INSTRUCTIONS FOR INSTALLING MODIFICATION KITS 182196 AND
182197 TO PERMIT OPERATION OF MODELS 32 AND 33 (RESPECTIVE-
LY) PERFORATOR UNITS WITH DRY NONOILED TAPE

SPECIFICATION 504985

Figure 1 - Punch Mechanism

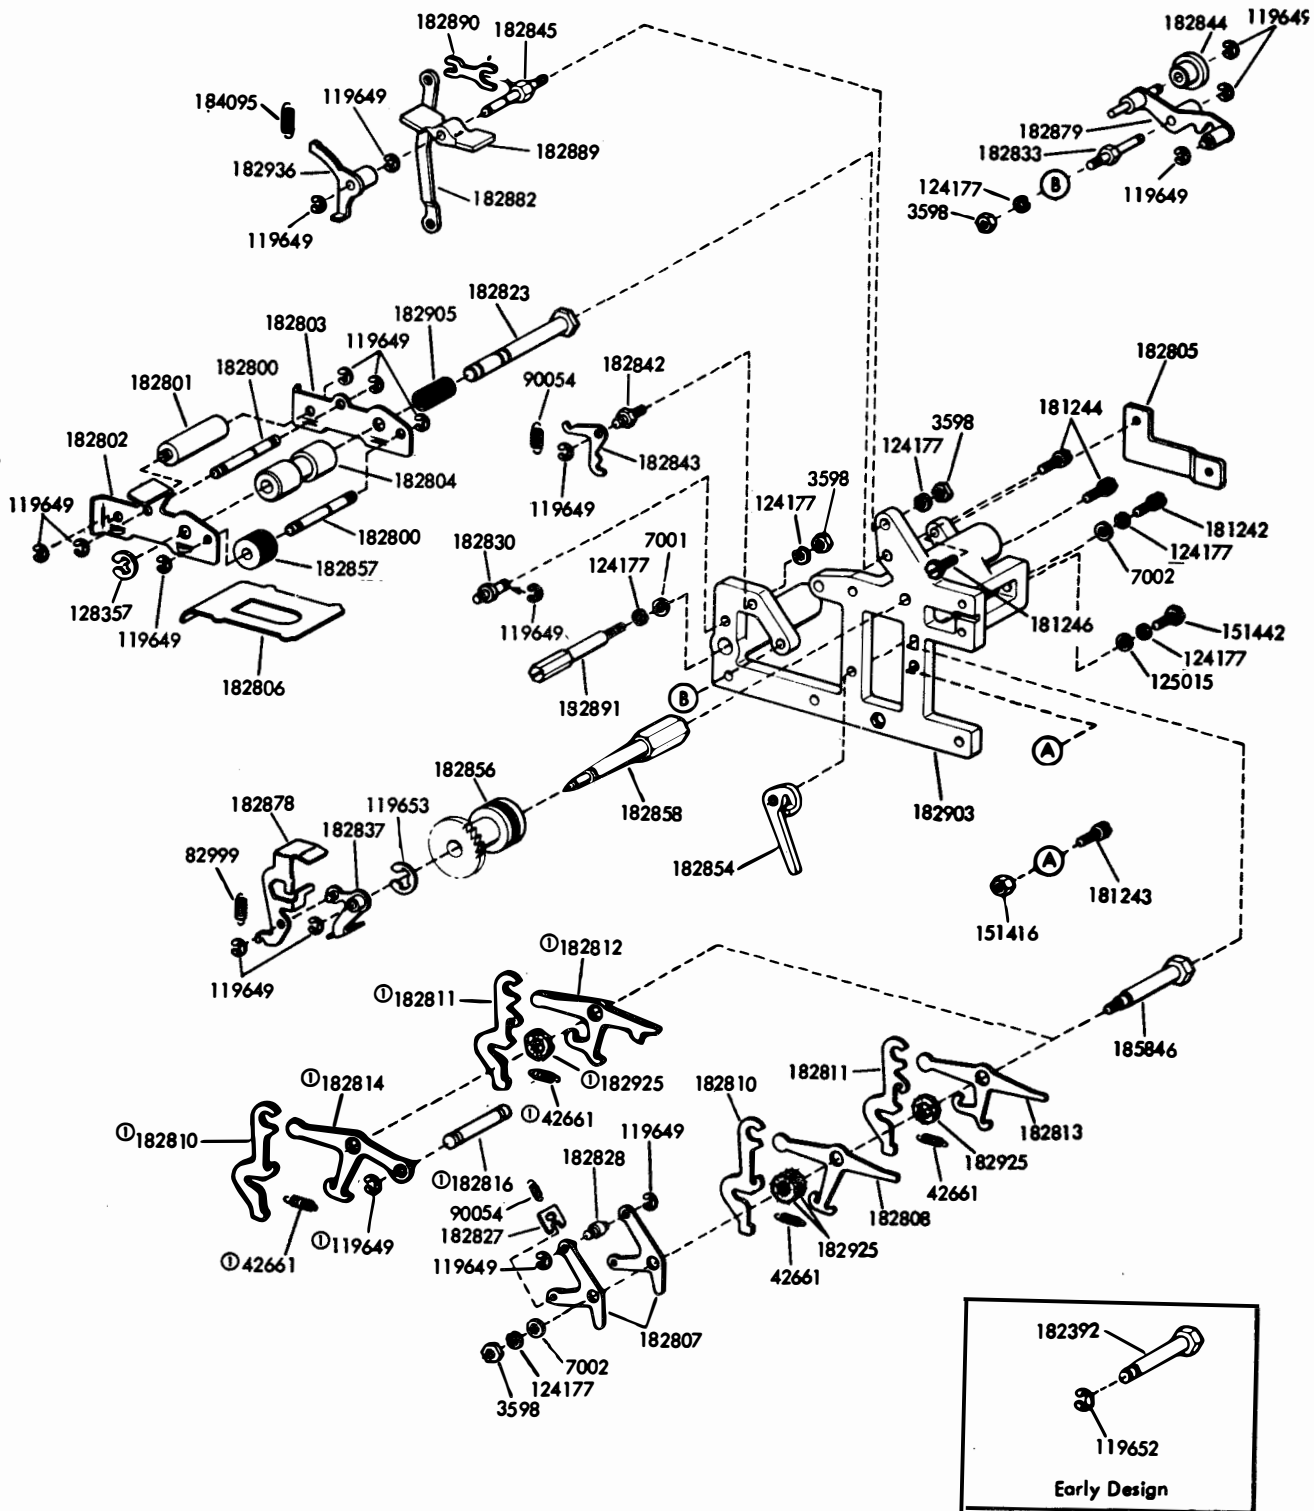
- 2.01 See Figures 1 and 2 for parts referenced in subsequent paragraphs.
- 2.02 Remove and retain the two 4-40 hex screws and associated lockwashers securing the punch block to the casting. Discard the existing punch block assembly. Discard the spacer 182838, if used, but retain chad chute 182908, its mounting hardware, and chad chute extension 182915.

- 2.04 Remove and discard post 182391. Replace it with post 185847 using the existing 6-40 mounting screw.
- 2.05 Remove and discard retaining ring 119652 from post 182392.

- 2.10 Remove and discard post 182392 and substitute post 185846 using the existing mounting hardware. Tighten this post friction tight only.
- 2.11 Remove screw 181244 used to fasten one end of spring bracket 182455 to post 182427 and retain this screw. Next loosen, but do not remove, the other screw 181244 fastening the other end of the spring bracket.

- 2.12 Insert support plate 185848 over the post 182427. Replace screw 181244 holding spring bracket 182455 and tighten both mounting screws.
- 2.13 Pivot support plate 185848 out of the way to facilitate subsequent reassembly operations. Reassemble the levers and felt washers 182925 on the post 185847 being careful to insure that the levers are replaced in the proper sequence with respect to their proper slot position. Pivot these levers toward the front of the unit to facilitate the following assembly.

- 2.19 Place a flat washer 7002 over the shoulder of post 185846 and pivot the support plate 185848 into position over the threaded portion of the post. Use another flat washer 7002 with a lockwasher 124177 and nut 3598 to secure the support plate to the post. Note that this nut should be friction tight only.

- 2.20 Use the screw with lockwasher 181242 to secure the support plate on post 185847. This screw should be tightened.
- 2.21 Secure the remaining free portion of the support plate to the punch block assembly with a screw 153817, lockwasher 110743, and flat washer 2034. This screw should be tightened.

- 3.01 Refer to Bulletin 273B Volume 2 for complete readjustment requirements except for those listed below and check or remake any adjustments which have been disturbed during the installation of either modification kit 182196 or modification kit 182197.
- 3.02 The punch penetration adjustment has been modified. Use the following procedures and requirements.

With the perforator in the ON position, the RUBOUT combination in the 8-level perforator or with either figures D or RUBOUT combination in 5-level perforator and the printer function shaft and power bail in its forwardmost position, there should be at least 0.017 inch but not more than 0.037 inch clearance between the top surface of any code lever and the bottom surface of the punch block.

Loosen the code lever post mounting screw and the support plate nut both friction tight. Position the post with a screwdriver held against the pry point to meet the requirement and then tighten both the screw and nut.

Figure 2 - Punch Mechanism (continued)

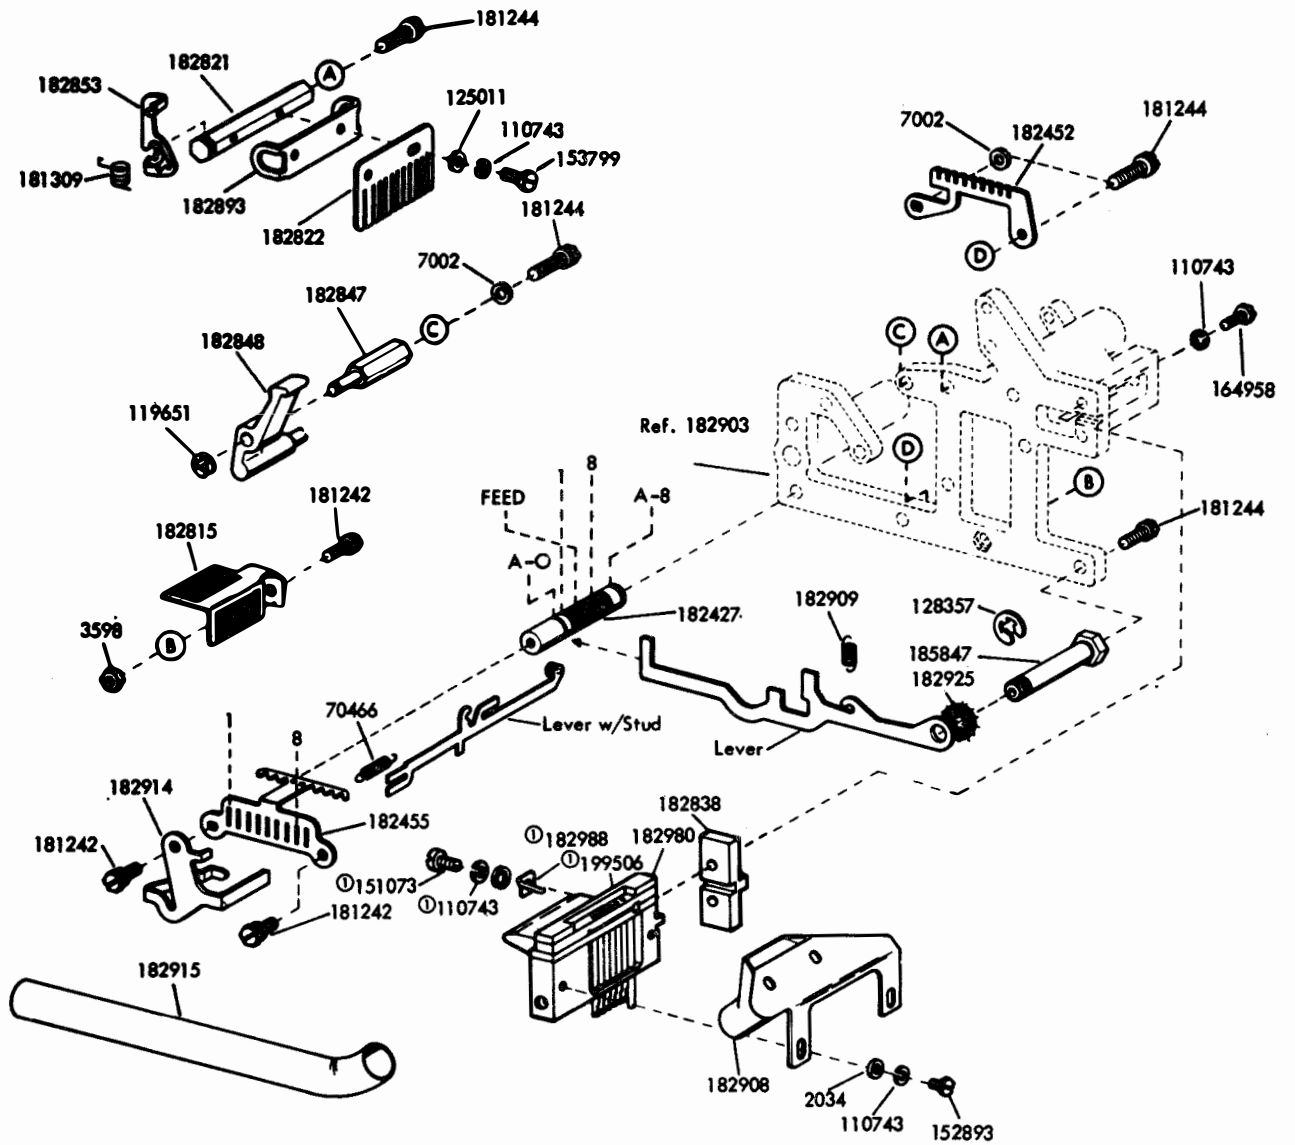
- 2.16 Reassemble the feed pawl detent roller subassembly onto the new post 185846. Replace hook 182853 and springs 82999 and 45104, then use a new spring 185776 in place of the spring 90054 which was previously discarded.

- 2.17 Replace the backspace lever assembly onto the post 182858 and secure it with its retainer ring 119649.
- 2.18 Assemble chad chute 182908 and its associated mounting hardware onto the new punch block assembly 182980. Align the punch pin levers with their respective slots in the punch pins and slide this assembly into place. Fasten with the screws and washers that were formerly used for the old punch block.

Figure 3 - Modified 185706 Bracket

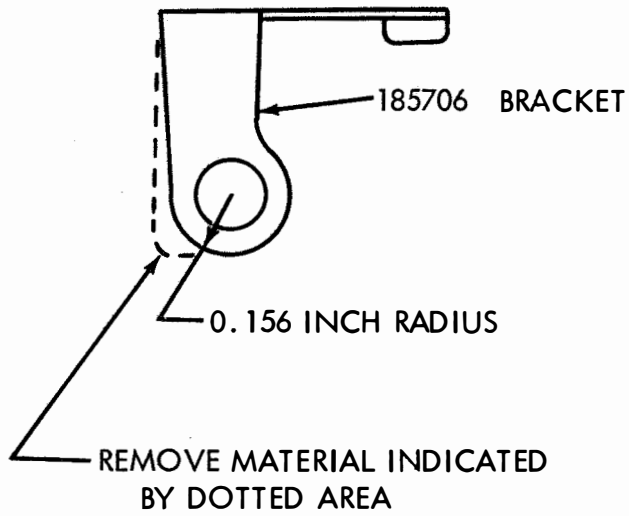
3.06 Early design units equipped with modification kit 185705 for fan-fold tape require that bracket 185706 furnished with that modification kit be modified to prevent interference with support plate 185848 (Figure 3).

MODIFICATION INSTRUCTIONS FOR 185706 BRACKET
REQUIRED ONLY ON OLD STYLE UNITS EQUIPPED WITH THE
MODIFICATION KIT 185705 FOR FAN-FOLD TAPE
